AMMONIA-UREA FERTILIZER COMPLEX AT NAMRUP, ASSAM
[NIT NO. PNMM/PC230/E/001 DATED 20.11.2025]

CORRIGENDUM-4 TECHNICAL (PROCESS) DATED 10.02.2026

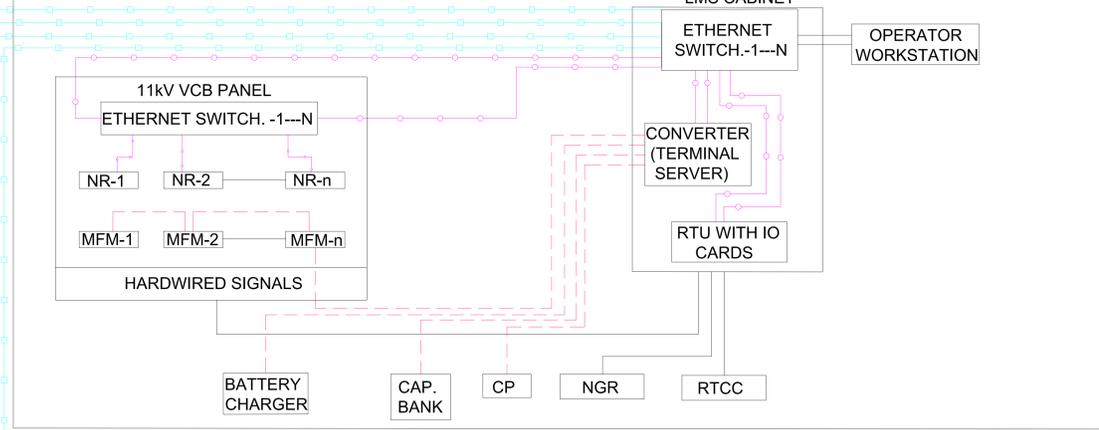
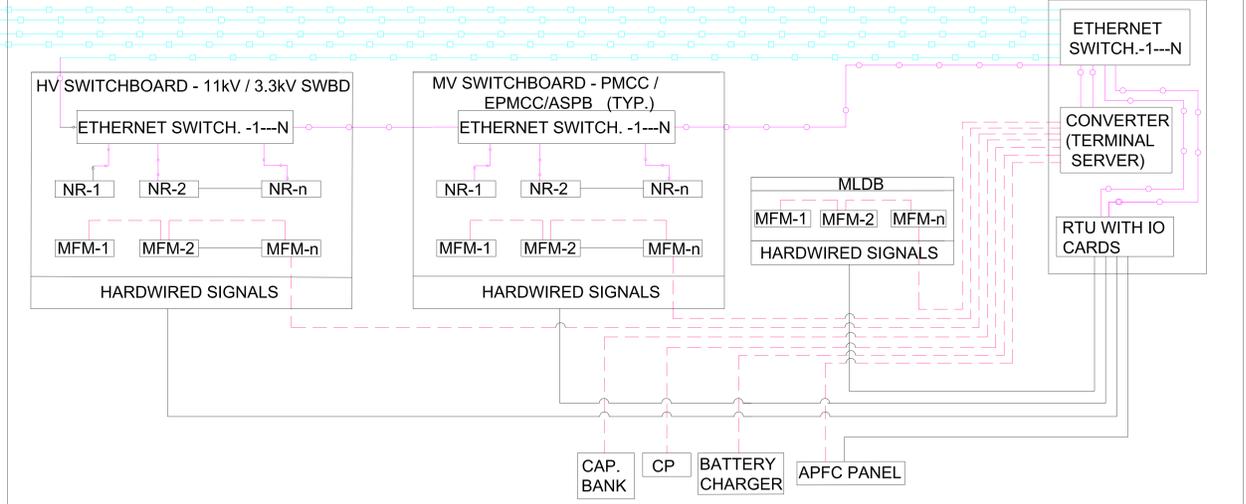
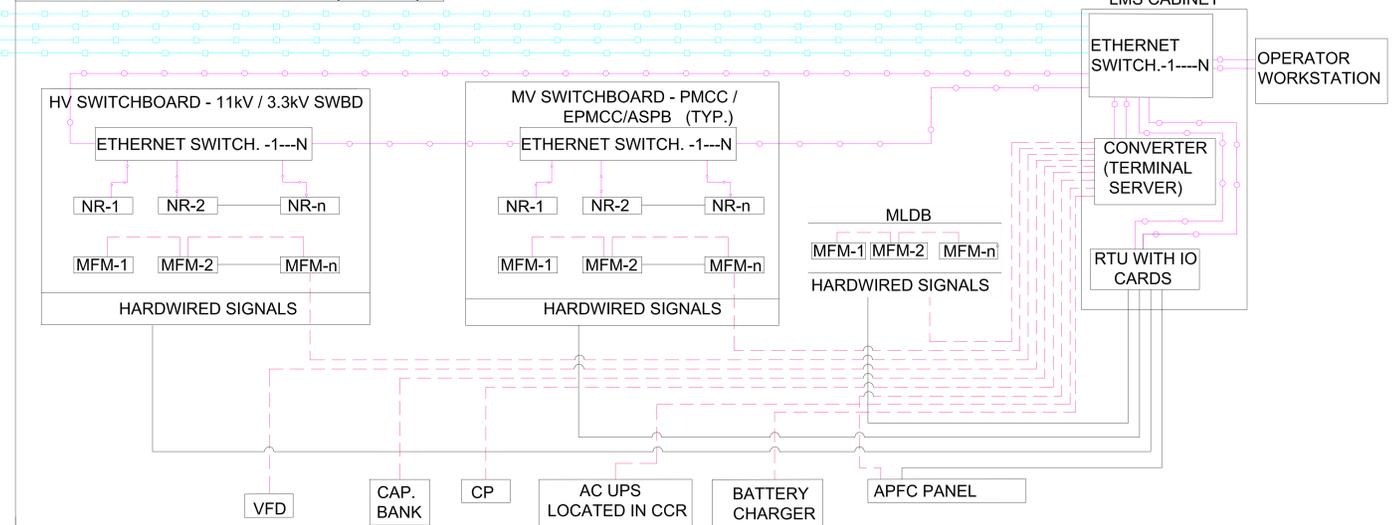
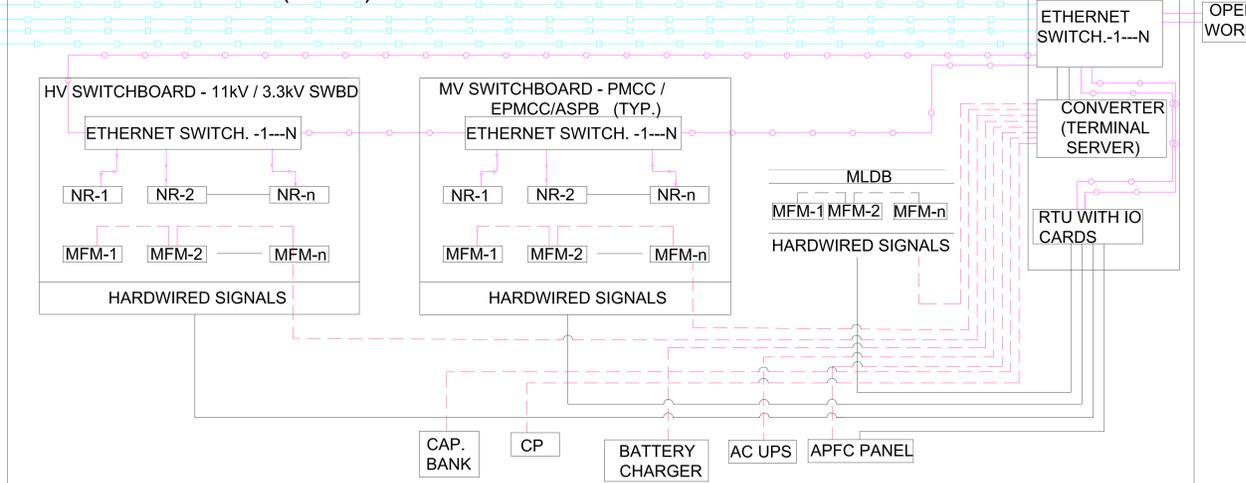
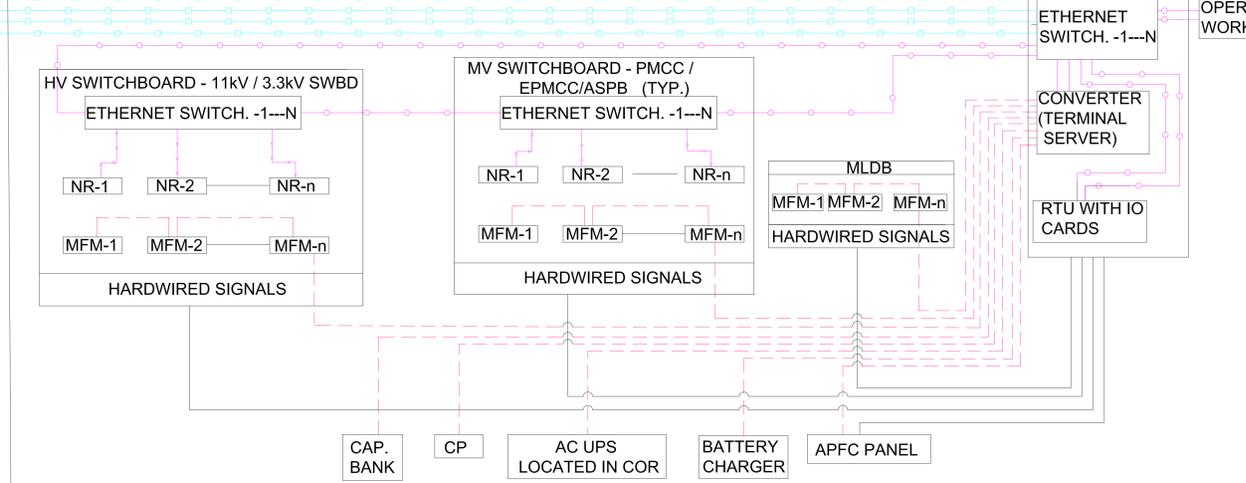
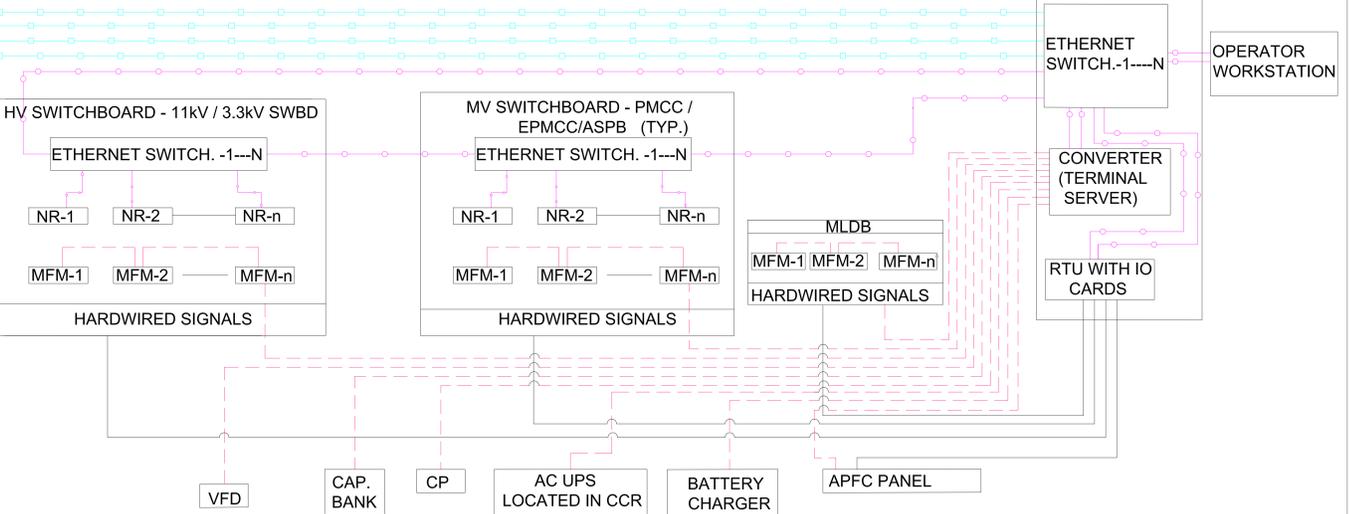
27.	SEC – 5.3	--	--	LMS Block Diagram (PC230-PNEL-1204, Rev. 0)	M	Revised “LMS Block Diagram (PC230-PNEL-1204, Rev. 1)”
28.	SEC – 9.0	33 OF 44	2.7 Sl. No. 21	Electrical Equipments/Items LMS	A	Following additional Mandatory Spares shall be provided for Load Management System: K) Servers: 1 no. of each type L) HMI: 1 no. M) Temperature Measuring Device/Cards: 10% N) Programming Laptop with License software: 1 no.
